March 15, 2019

NOTICE OF ADDENDUM ADDENDUM NO. 3

CONTRACT NO. 7528, PROJECT NO. 10305 NAKOOSA TRAIL FLEET/FIRE/RADIO SHOP FACILITY

A-121

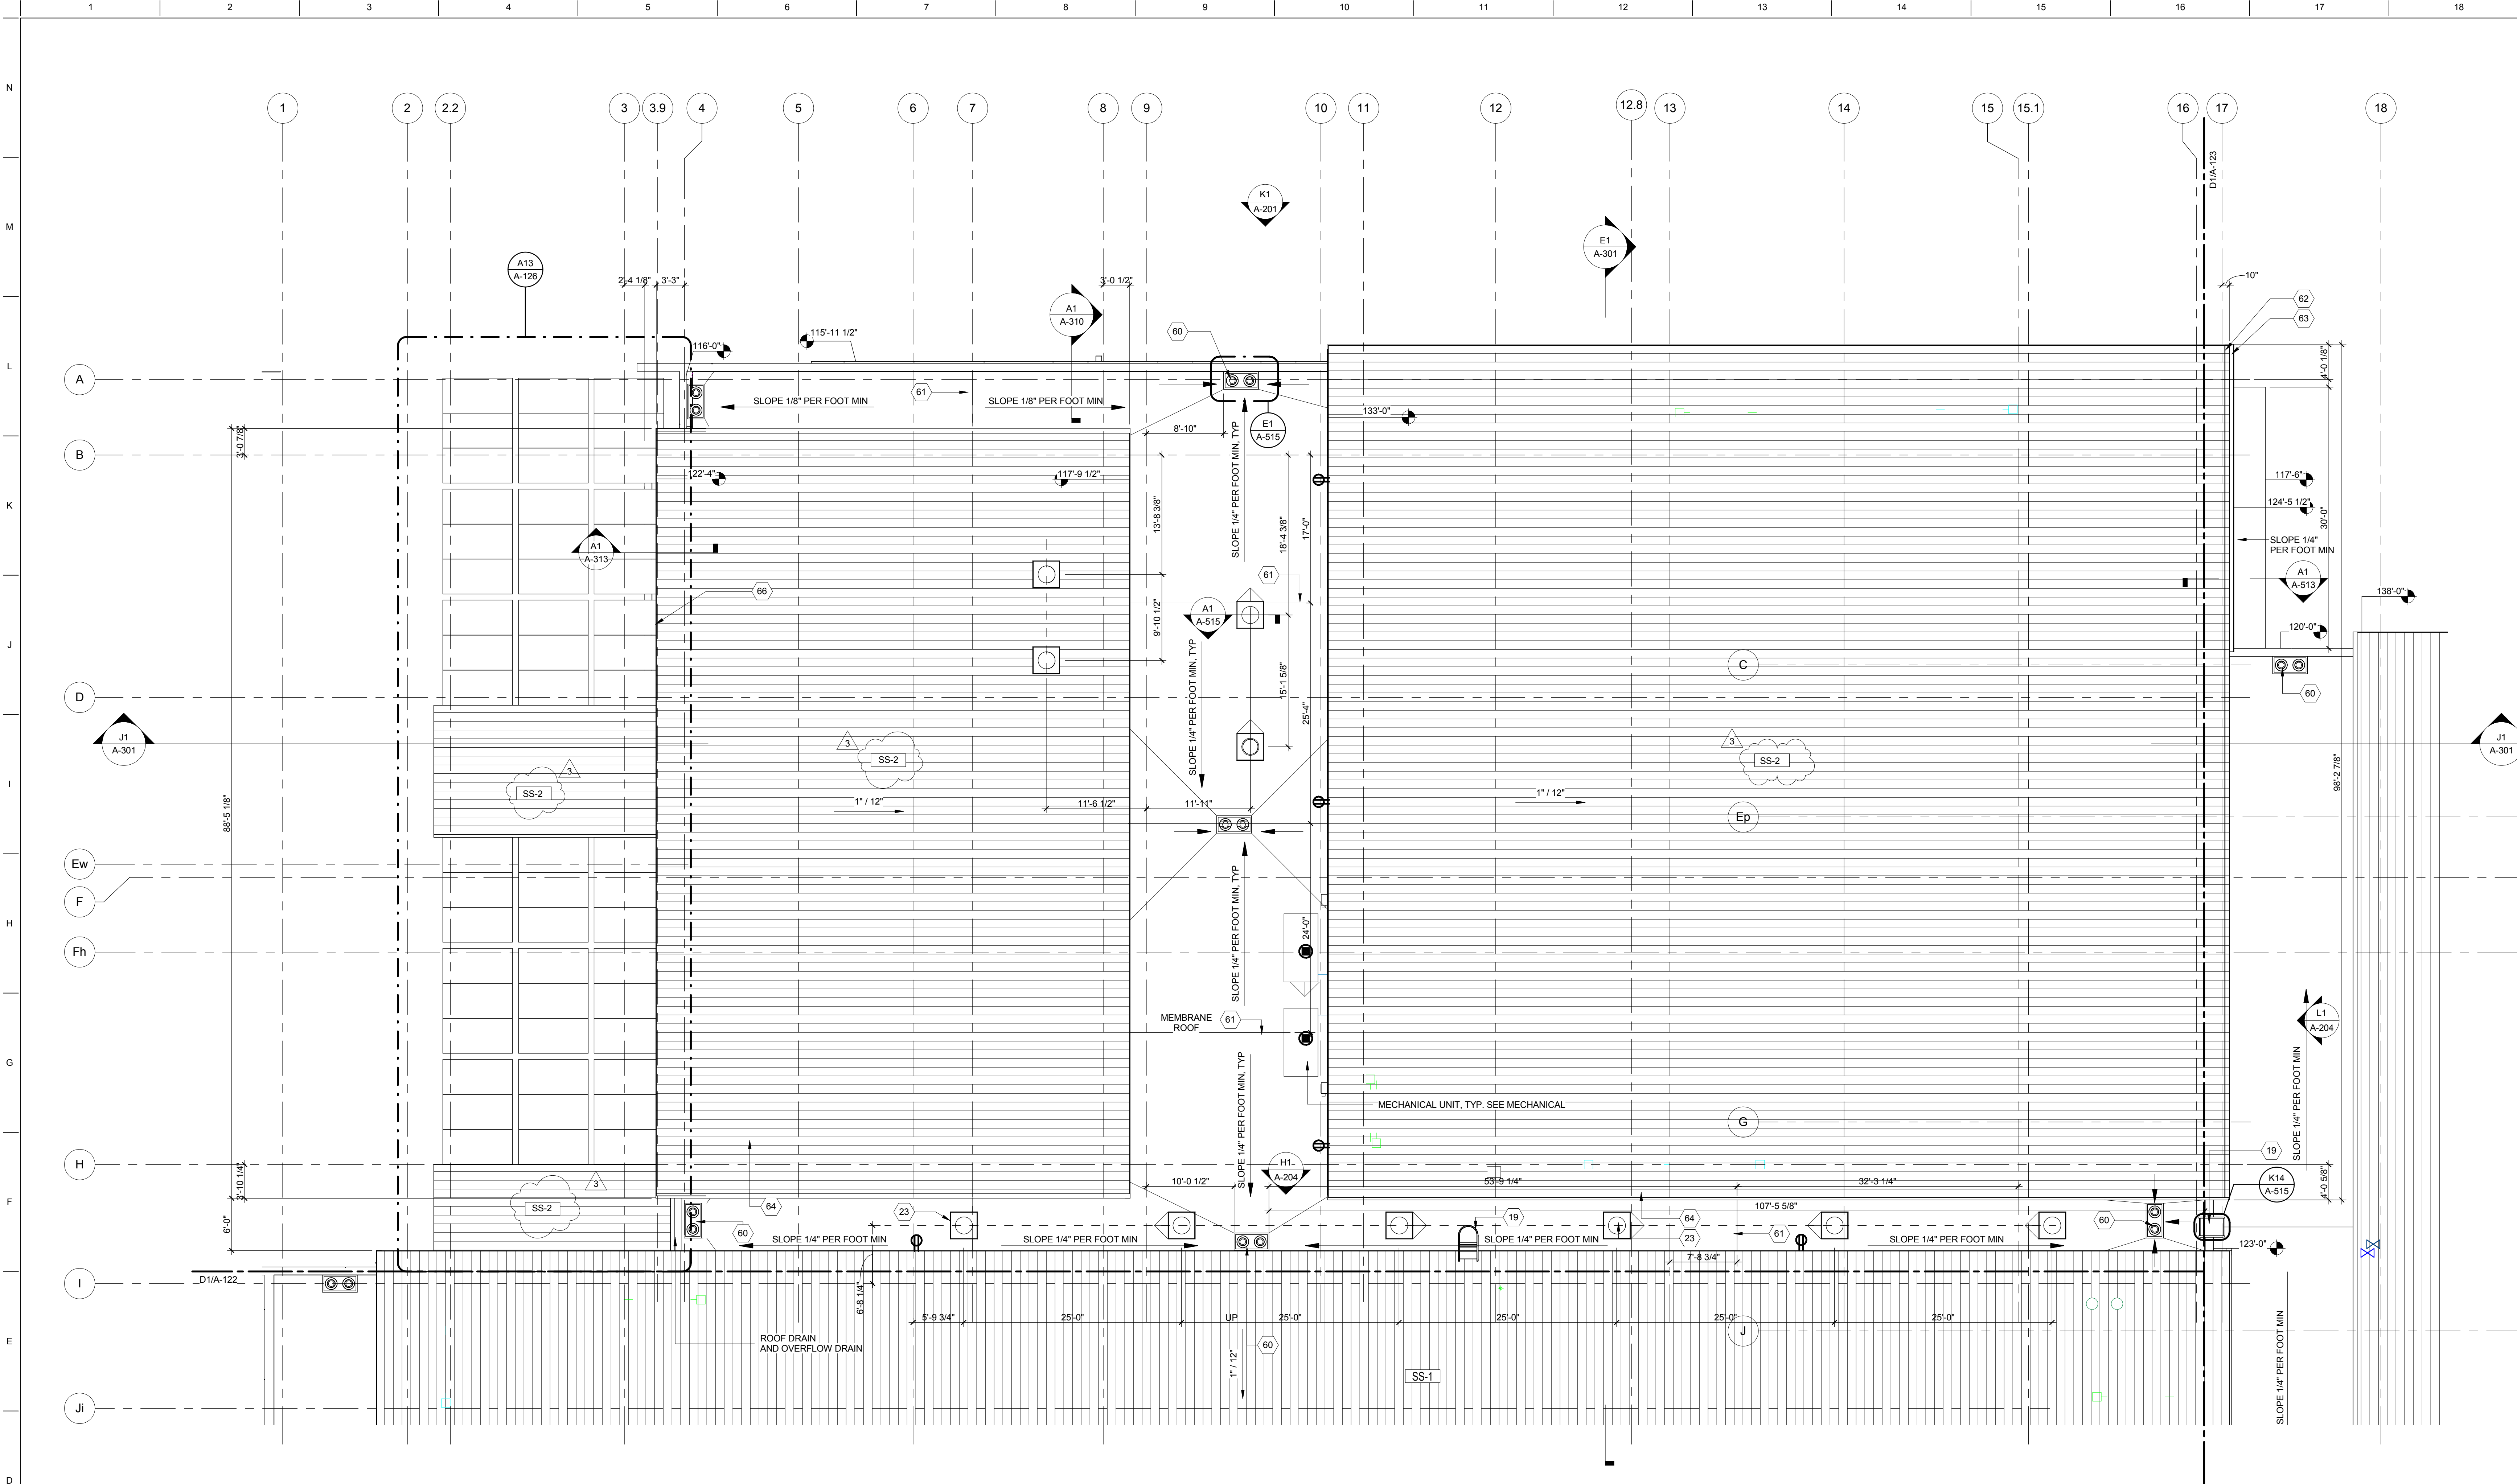
Q9: Keynote 19 on sheet A-121 calls out a ladder with metal cage. Our understanding of the revised OSHA fixed ladder rules is that caged ladders are no longer required or acceptable as a fall prevention device. Please advise if a caged ladder is still required.

KEY NOTES	
19	ROOF LADDER WITH METAL CAGE, TYP.

J1 SECTION @ ADMIN
1/8" = 1'-0"

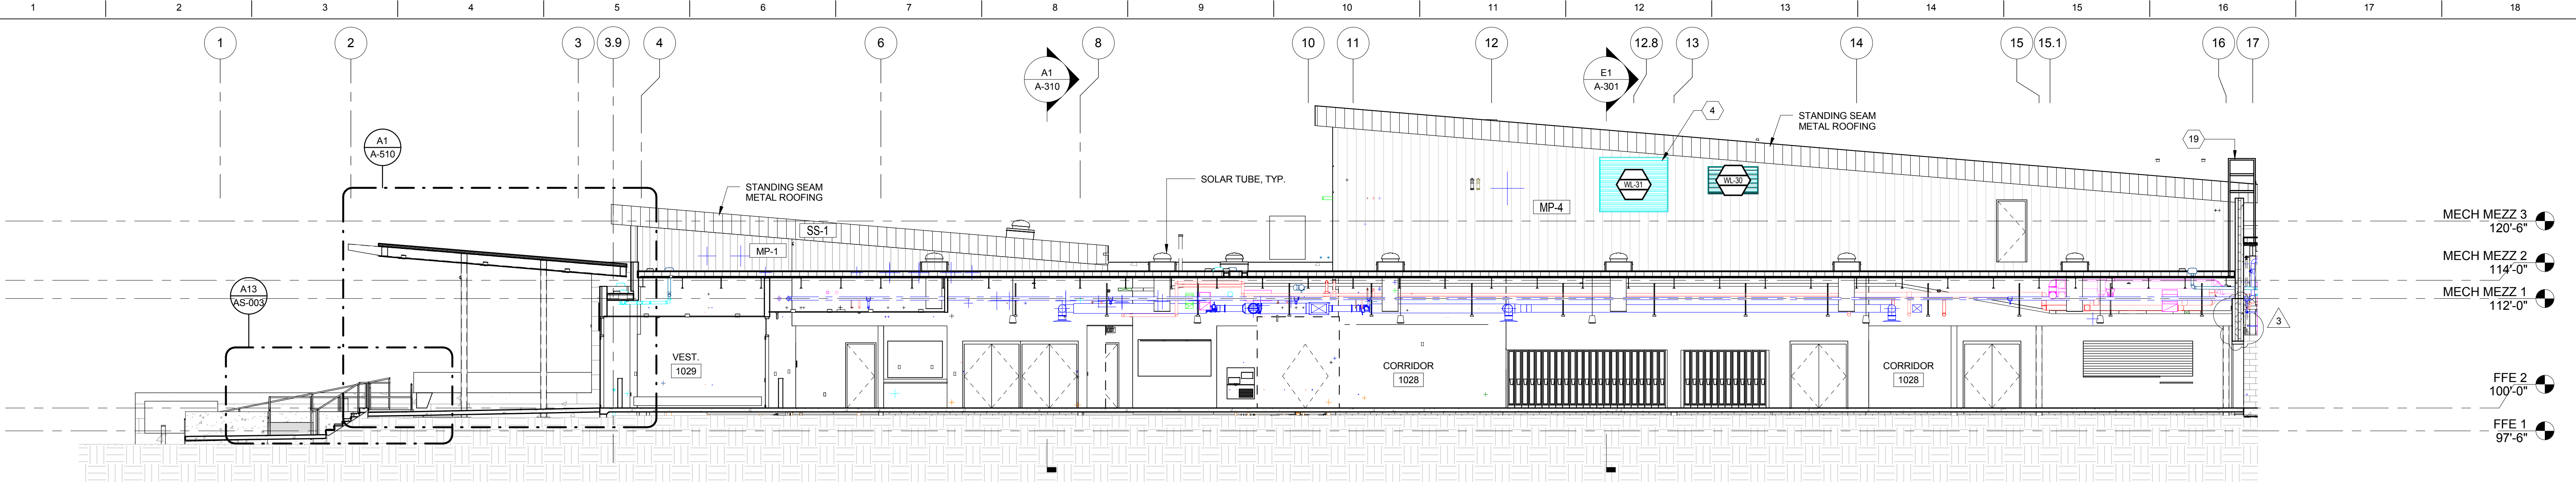
- Y. **MODIFIED** A-202-BUILDING ELEVATIONS to revise Key Note 13.
- Z. **MODIFIED** A-203-BUILDING ELEVATIONS to revise Key Note 13.
- AA. **MODIFIED** A-301-BUILDING SECTIONS to revise the wall between grid line 16 and 17 from 12" CMU to precast, and reduce height of CMU wall along column line 15 to stop at underside of mezzanine metal deck in detail J1.

A-302

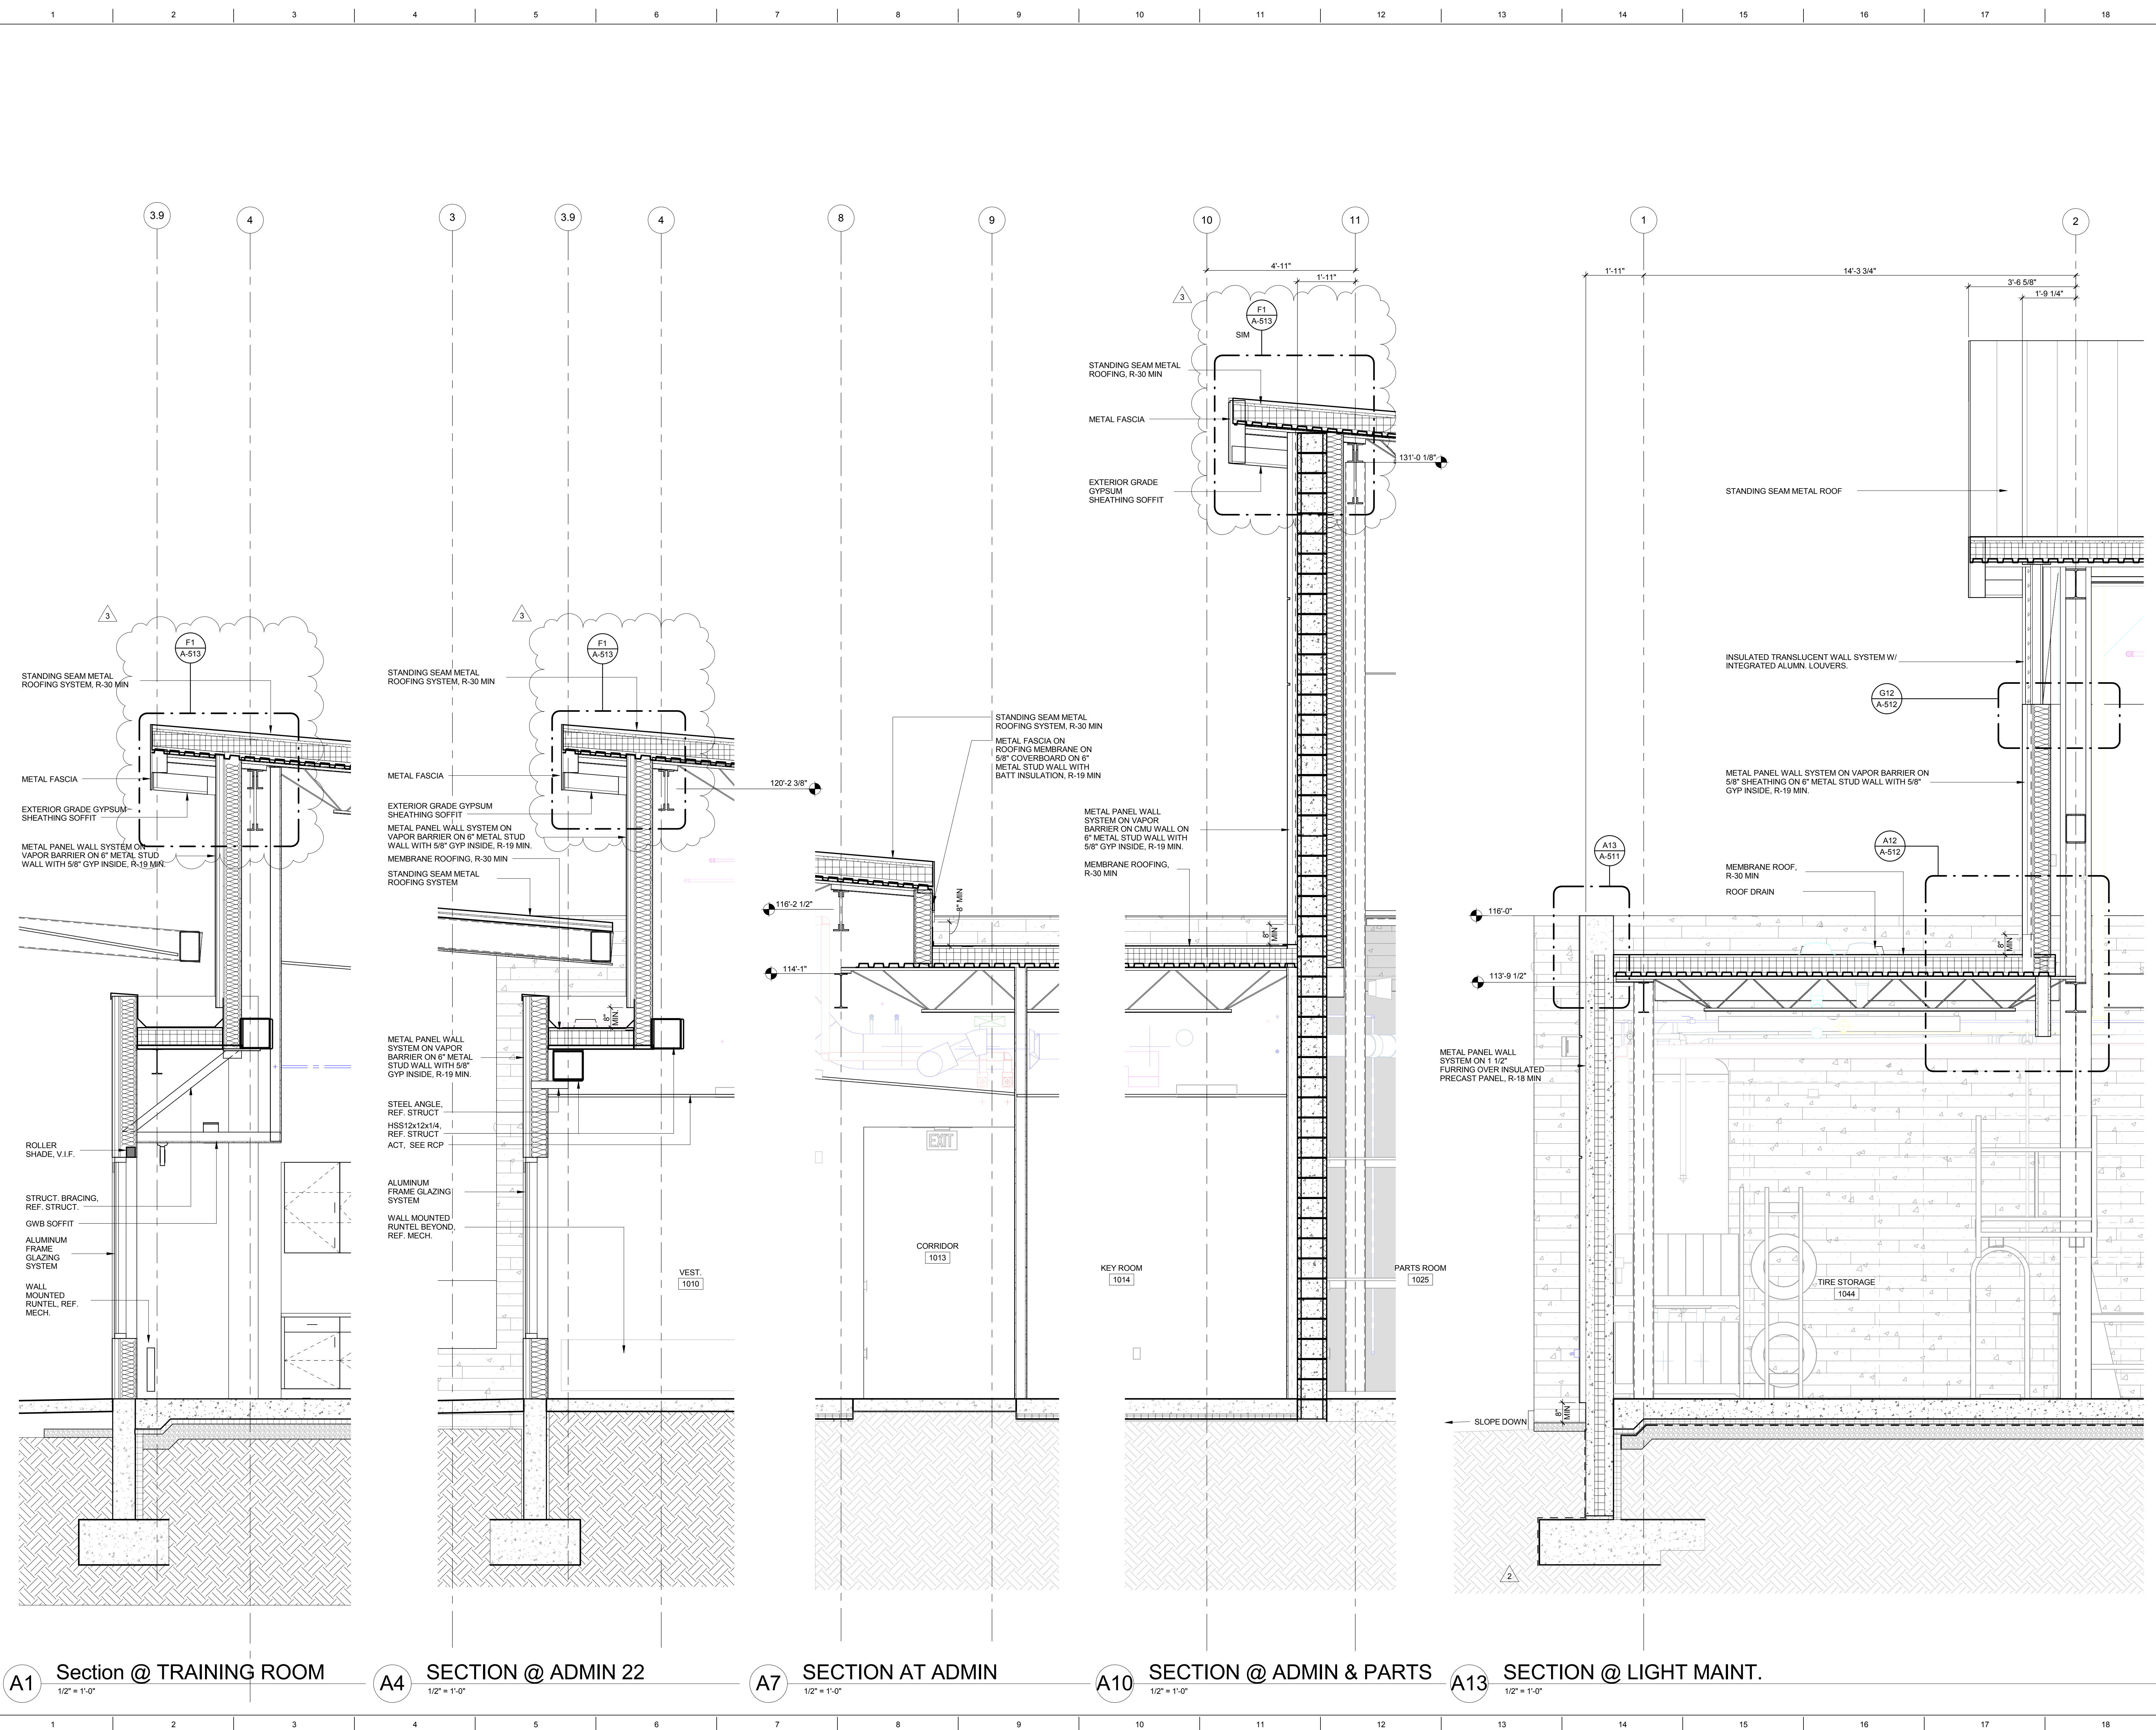
- BB. **MODIFIED** A-302-BUILDING SECTIONS to revise the wall between grid line 16 and 17 from 12" CMU to precast in detail J1 and E1.
- CC. **MODIFIED** A-313-E/W WALL SECTIONS to add detail callouts in details A1, A4, and A10.
